**Case No. P18-22  
525 West Liberty**

**CITY of MEDINA**  
**Planning Commission**  
**February 14, 2019 Meeting**

**Subject:** Amend September 13, 2018 approval - Site Plan and TCOV-Certificate of Appropriateness review for building façade rehabilitation

DATE: 08/25/18

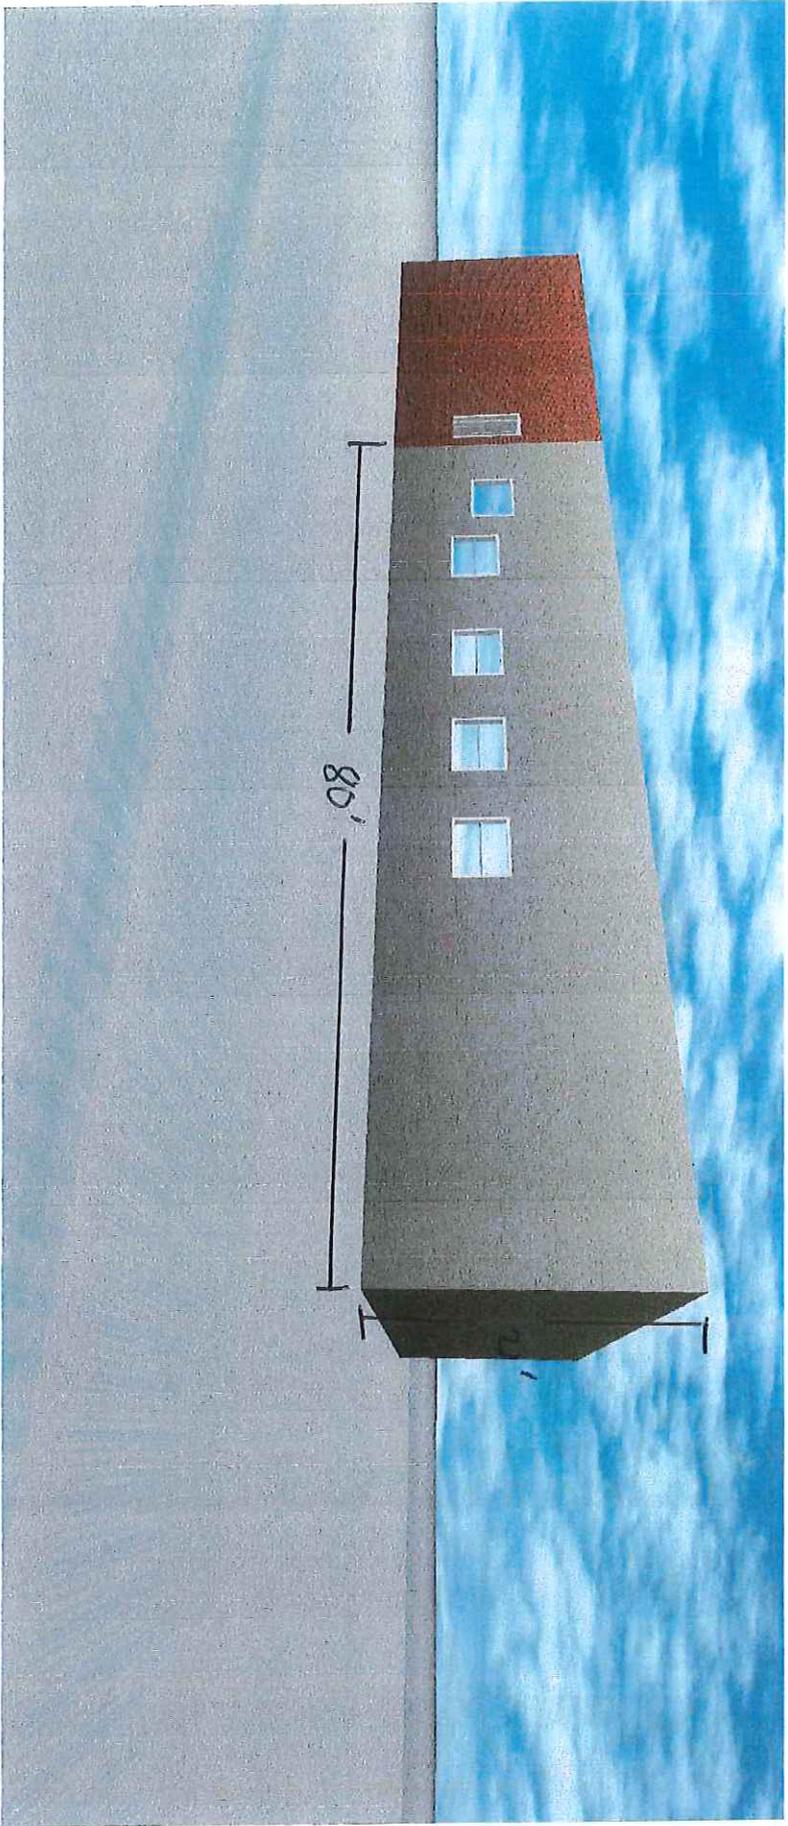
Demo of sand colored brick on west wallof building.Exposing the block behind the brick. From there we have to ways to finish it out 1 be that we would paint the block to match the block that is already painted. 2 lay a coat of stucco on the block then paint.

RECEIVED  
AUG 27 2018  
By *Jm*

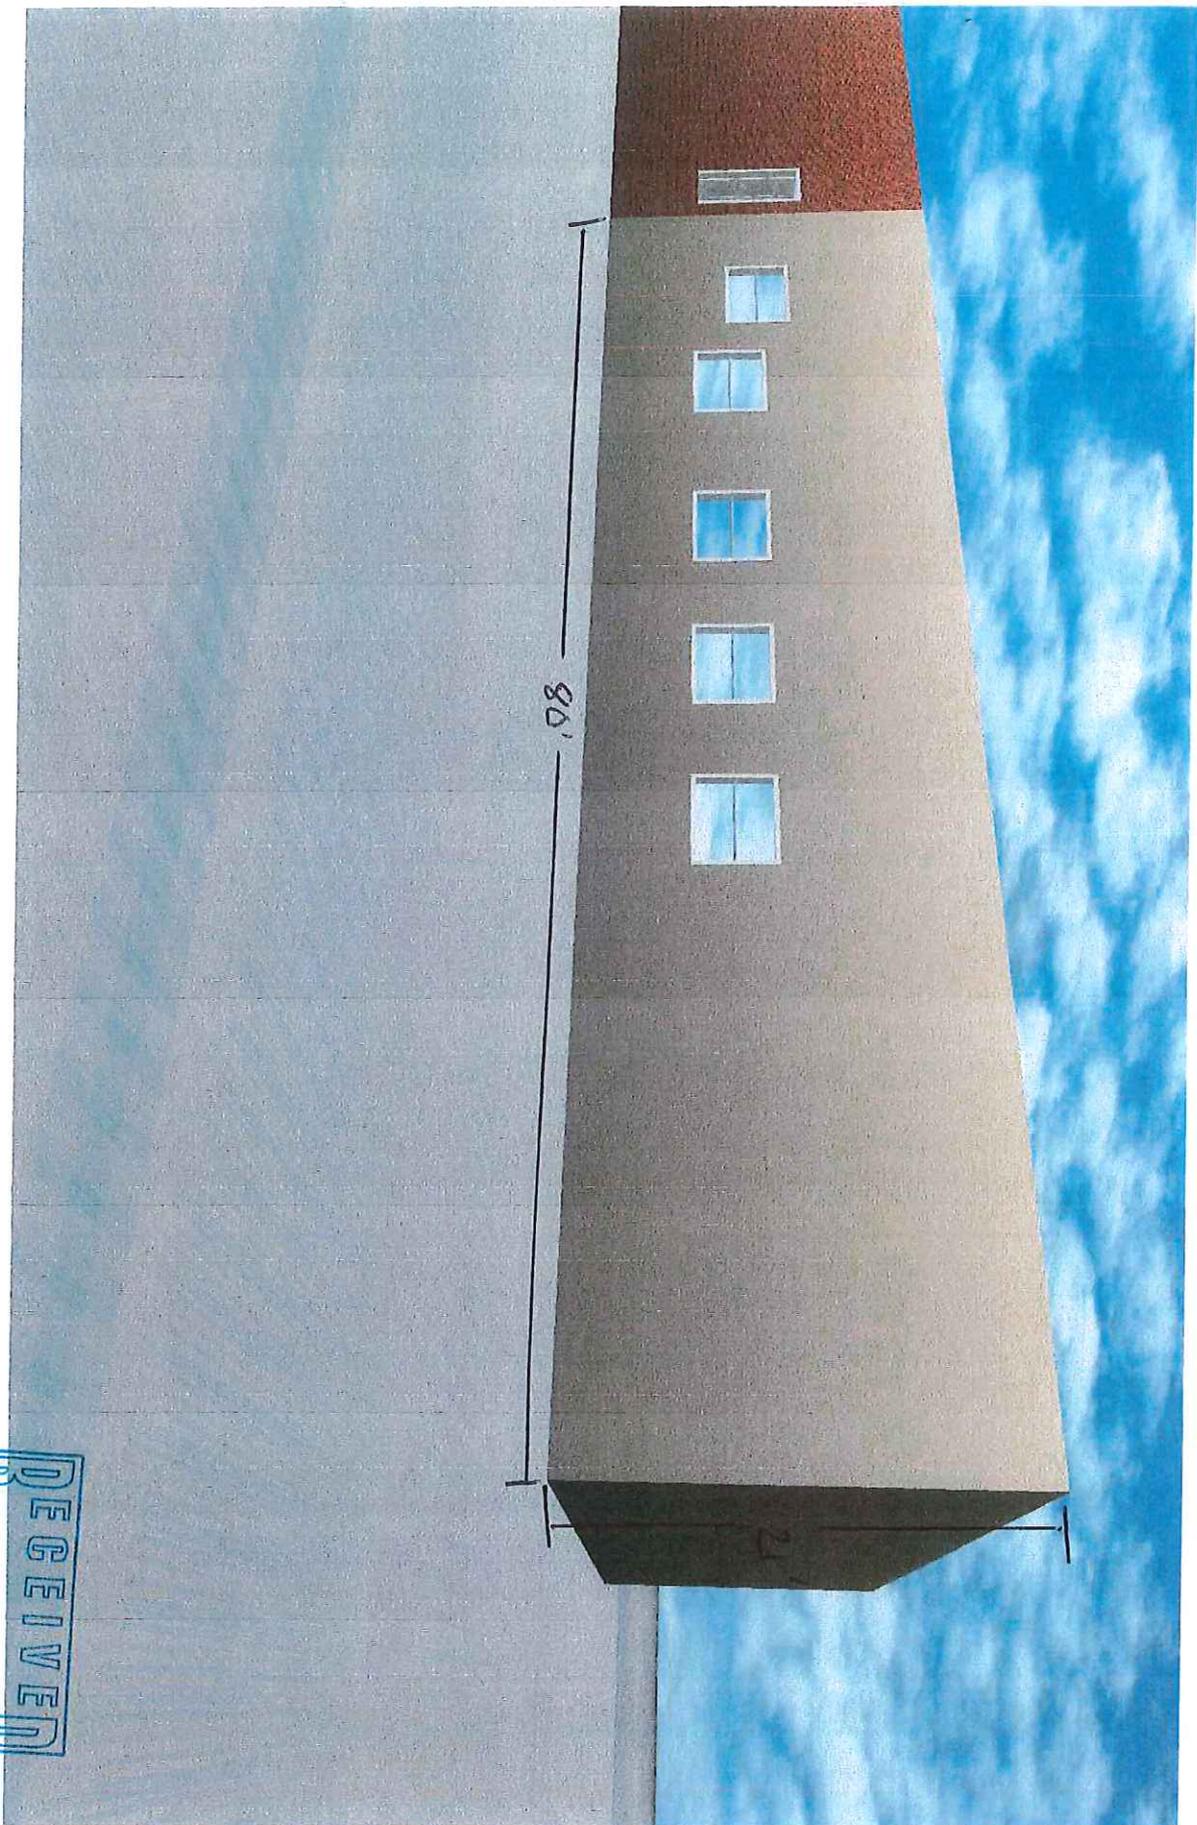
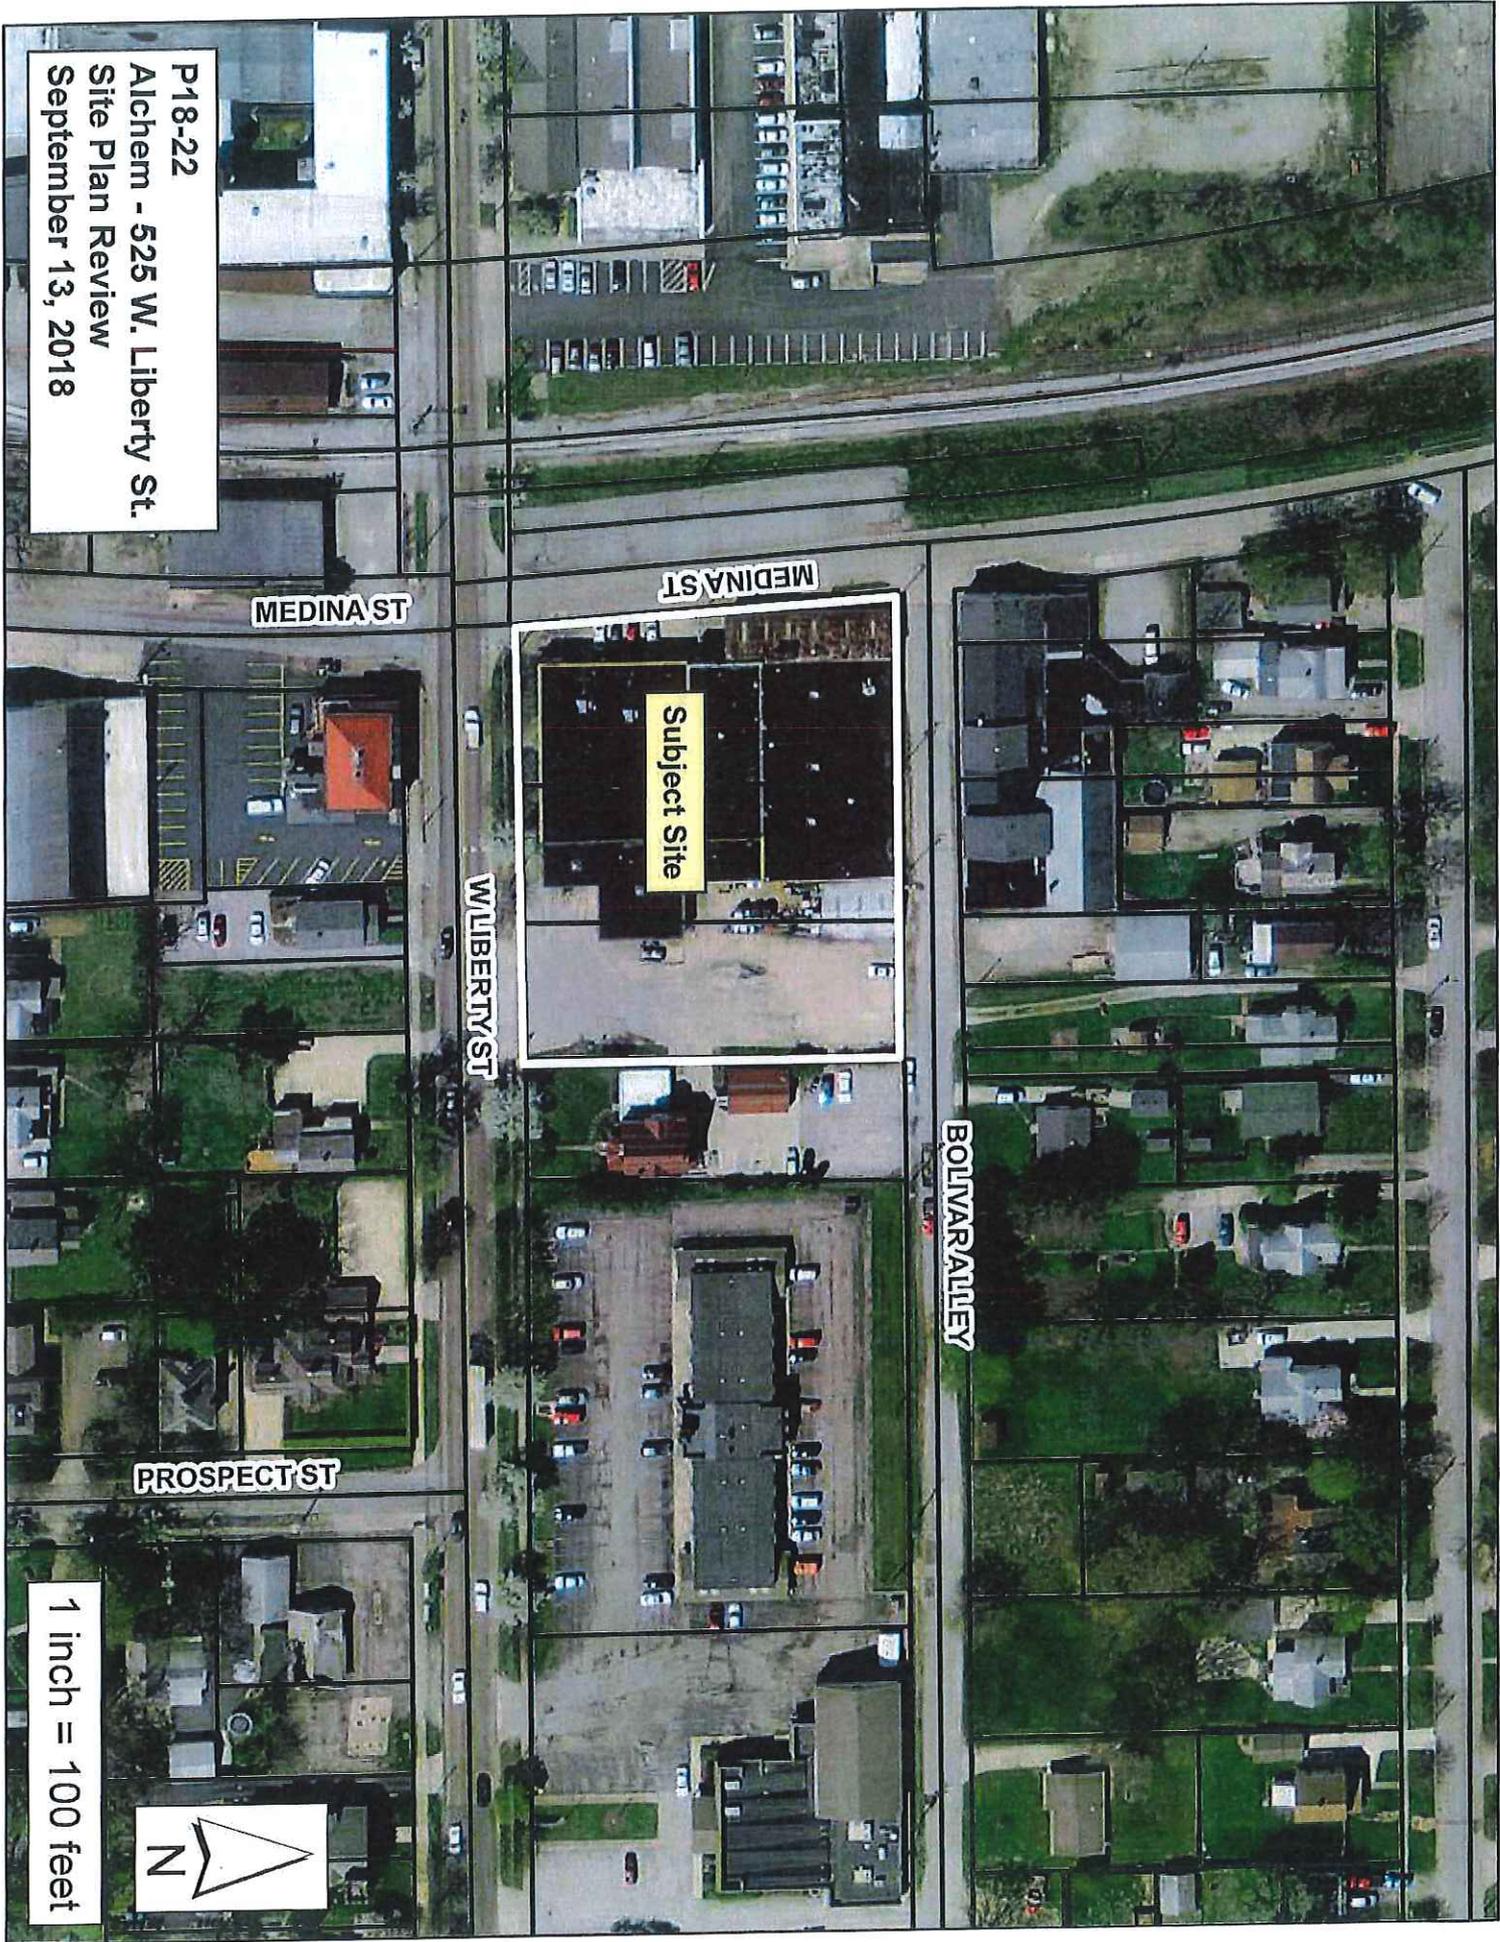
The proposed finish plan for the west building façade may not be consistent with each of the above design guidelines. Leaving the underlying structural concrete block exposed or installing a stucco finish on the west building façade is considered inappropriate and discouraged by guideline 1109.04(c)10.

In reviewing the proposed final exterior finish plan for this building, the plan could certainly be determined to be in conflict with the letter of the above guidelines.

If the painted concrete block finish façade is approved for the west side façade, special attention must be paid to the transition at the southwest building corner where the concrete block would transition to the existing face brick of the south building façade. The corner must be treated in a industry appropriate finish method to prevent a jagged or clumsy edge.

1. Review and approval of applicable permits by the City of Medina Building Department.
2. The subject building façade shall be finished as painted concrete block using a paint color consistent with the existing south half of the existing building.
3. The applicant will work with City staff during permit review to verify appropriate use of colors, window design and the material transition at the building's southwest corner.
